Amendment 3

Solicitation Number 25-01

Temporary School Facilities for Colegio Ponceño

STATUS

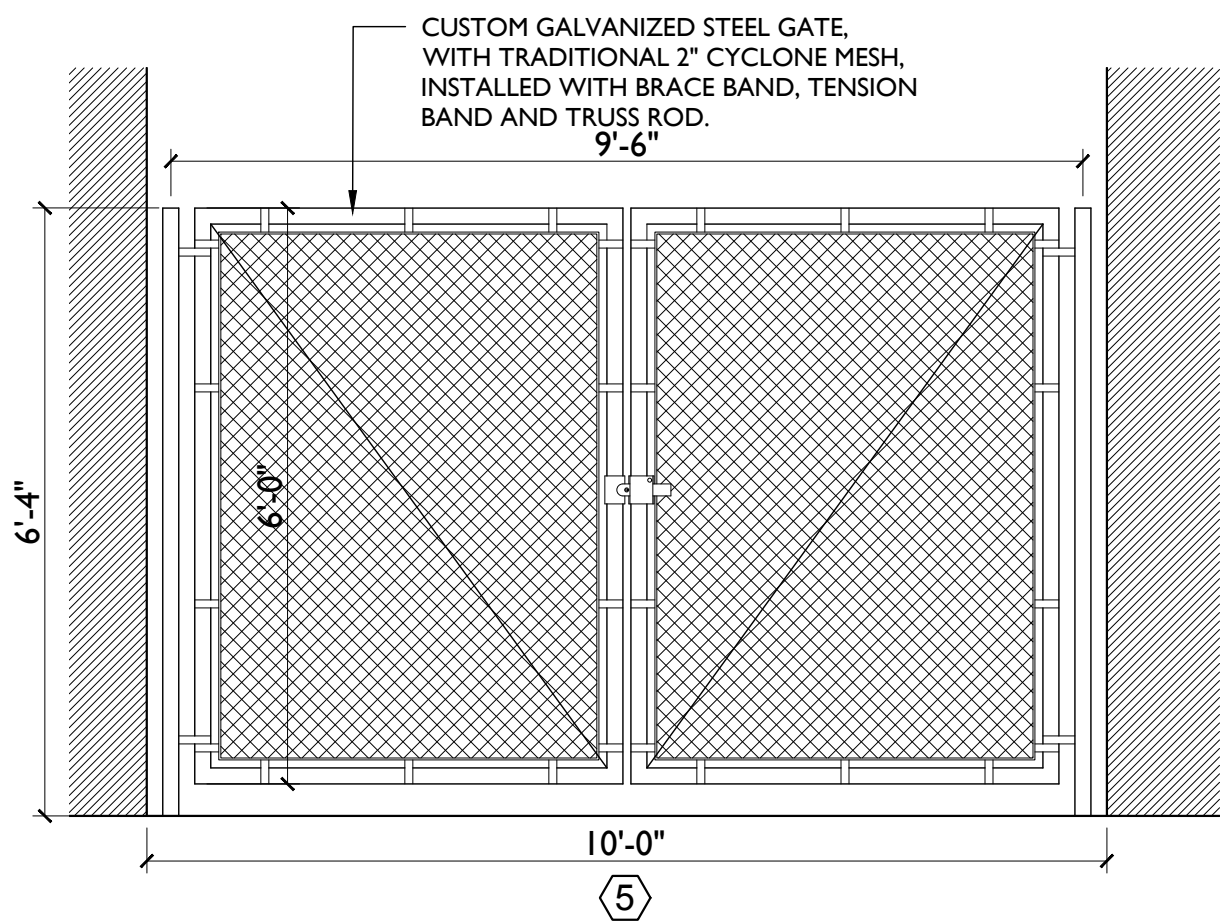
12. Question 19L: We previously requested the scope of work in the Pavilion to accommodate the Physical Education facilities (offices, classroom, gym, and restrooms). Although Addendum No. 2 states "Please refer to the attached drawing," these drawings were not uploaded to the website. We need elevations and sections to help clarify the work. Sheet AS-101 shows it best, but a lot of information is missing to fully understand it. Is this a new construction over part of the existing court? Is it a basement to be modified beneath the existing court? If it is a modification area, does it include any demolition by the Proposer, or as indicated in Question 19Q, is there no demolition involved? There is also a lack of clarity regarding finishes, doors, etc.

Answer: That level is an existing condition on the Pavilion basement; selective demolition is required, and new construction for one classroom, 2 offices, and storage. See attached drawings.
